# Land Excavation Special Use Permit:

SU-LE 23-1003

Development Services Department

Request to approve a Land Excavation Special Use Permit to remove up to 4 million cubic yards of materials from a 330.12-acre site generally located at 5015 South 41 Highway in Ruskin, FL. Approximately 96 acres of the subject property will be excavated to create two lakes. The applicant is requesting two waivers from the Land Development Code to waive from the access and hours of operation requirements.

### **DESIGN EXCEPTION REQUEST #1 – SUBSTANDARD RD.**

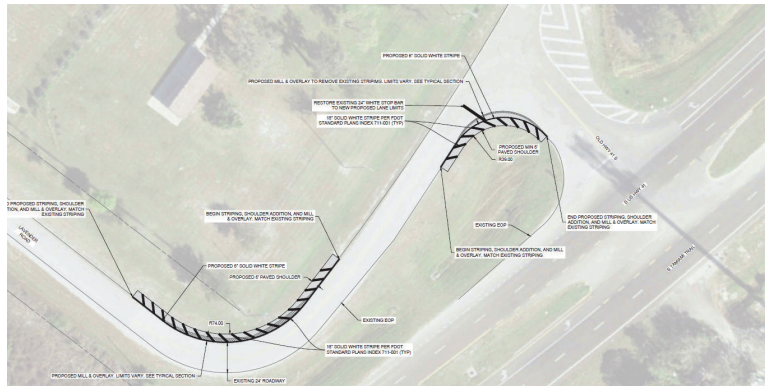
As Lavender Rd. is a substandard arterial roadway, the applicant's Engineer of Record (EOR) submitted a Design Exception request (dated January 18, 2024 and last revised January 30, 2024) from the Sec. 6.04.03.L. requirement to improve the roadway (between the project access and nearest roadway meeting standards, i.e. US 41) to current County standards. The County Engineer has reviewed the Design Exception request and found the request approval (on January 31, 2024) for the reasons stated therein. The specific deviations from the Transportation Technical Manual (TTM) Typical Section – 7 (TS-7) typical section include:

- The applicant is proposing certain paved and unpaved shoulder improvements in lieu of the 8-foot-wide stabilized shoulders, of which 5-feet shall be paved pursuant to TS-7; and,

5. If SU 23-1003 is approved, the County Engineer will approve a Design Exception request (dated January 18, 2024 and last revised January 30, 2024) which was found approvable by the County Engineer (on January 31, 2024). As Lavender Rd. is a substandard local roadway, prior to the excavation of material under this Special Use permit, the developer shall construct certain improvements to Lavender Rd. (i.e. sections of paved and unpaved shoulders in certain specified locations) as well as certain improvements to the driveway connection to the site (i.e. the addition of striping and rumble strips), all as detailed in the Design Exception.

SHEET NO: C-2

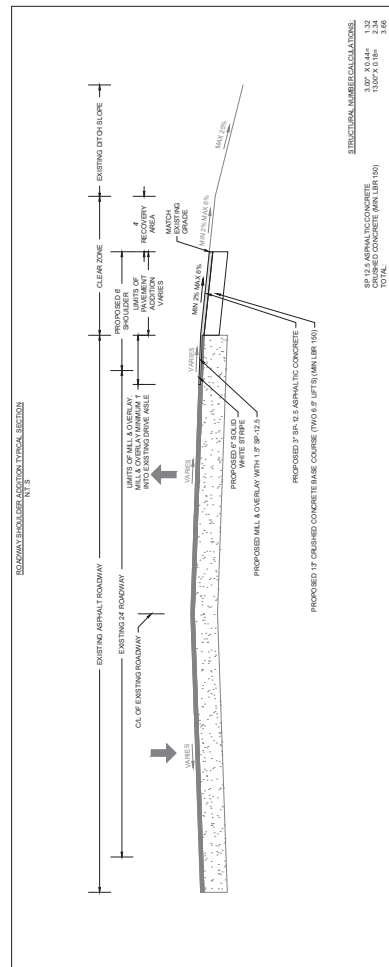
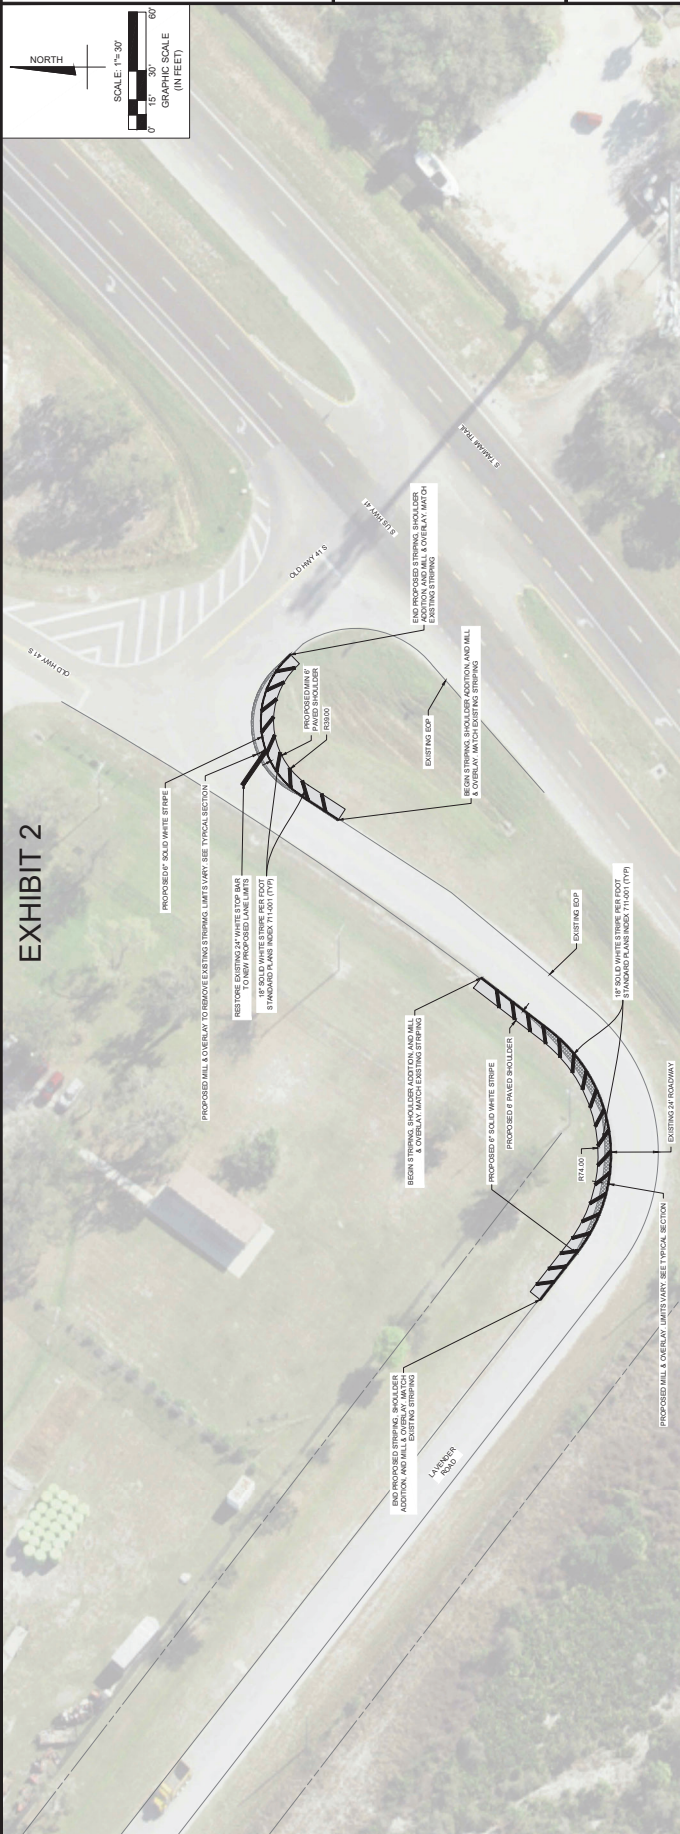
1. The existing ROW along Lavender Road is approximately 110 feet. The typical TS-7 section for a rural, two-lane undivided roadway requires a minimum of 96 feet of ROW with 12-foot lanes, 5-foot paved shoulder, a 2-foot grass area, open drainage and a 5-foot sidewalk.
2. Travel Lanes - The request is to maintain the existing 12-foot travel lanes.
3. Shoulder Width - The request is to maintain the unpaved shoulders, as no increase in traffic is anticipated with this modification to the project. However, on the two curves on Lavender Road from US 41 there is visible over tracking that is currently occurring. Therefore, in those areas, a 6-foot paved shoulder will be provided along with the 4-foot unpaved shoulder (See Exhibit 2). In addition, the project driveway is

approximately 36 feet and widens out where it connects to Lavender Road. To reduce the potential for trucks to cut the corner, on the east side of the driveway, a 6" solid white stripe and rumble strips east of the white stripe will be added (see Exhibit 3).

DRAWING NO. TS-7

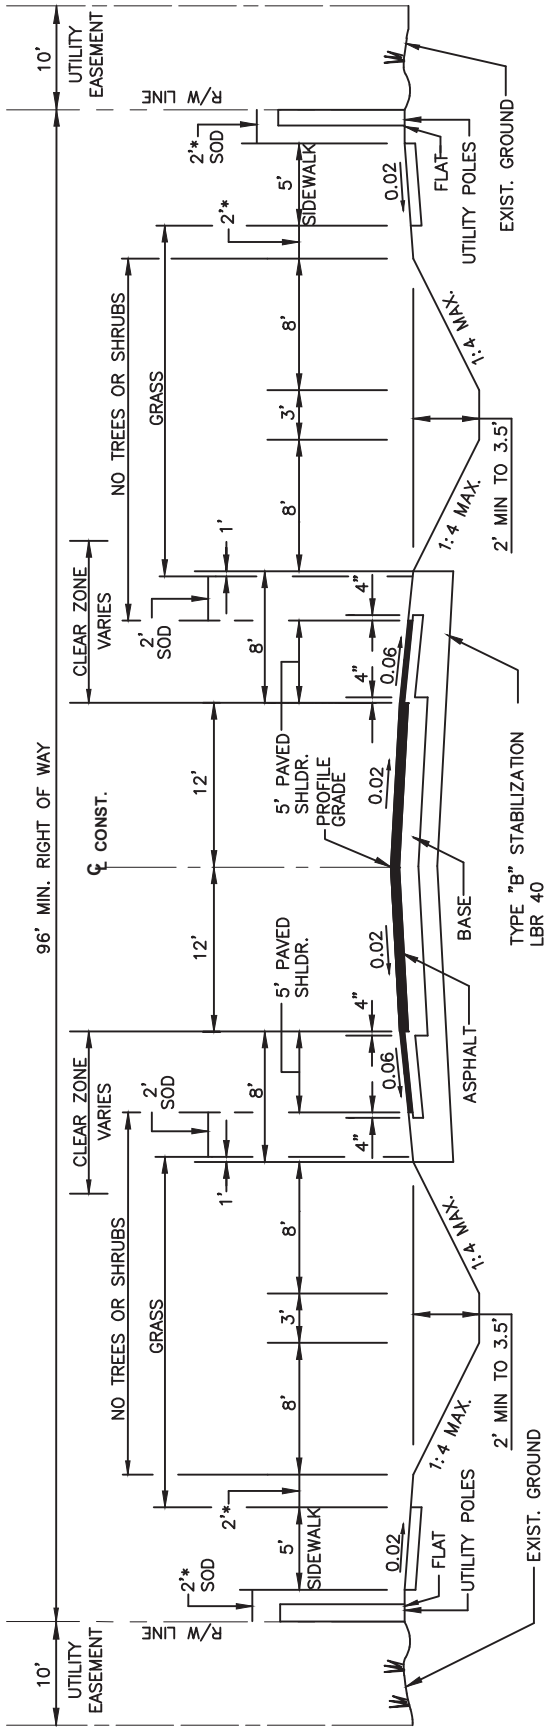
4. Drainage Swales – The request is to maintain the existing drainage swales. In the areas where the paved shoulders are being added, the side slopes will be regraded and will have the maximum 1:4 slope as identified in TS-7.
5. Sidewalks – The request is not to provide sidewalks on Lavender Road. This parcel is located in the Rural Service Area, over a mile from the Urban Service Area and no schools are located within 2 miles. In addition, this is an existing Barrow Pit facility and Lavender Road ends to the west of the existing driveway. There is no logical pedestrian traffic that would occur on this segment of Lavender Road currently or in the future.
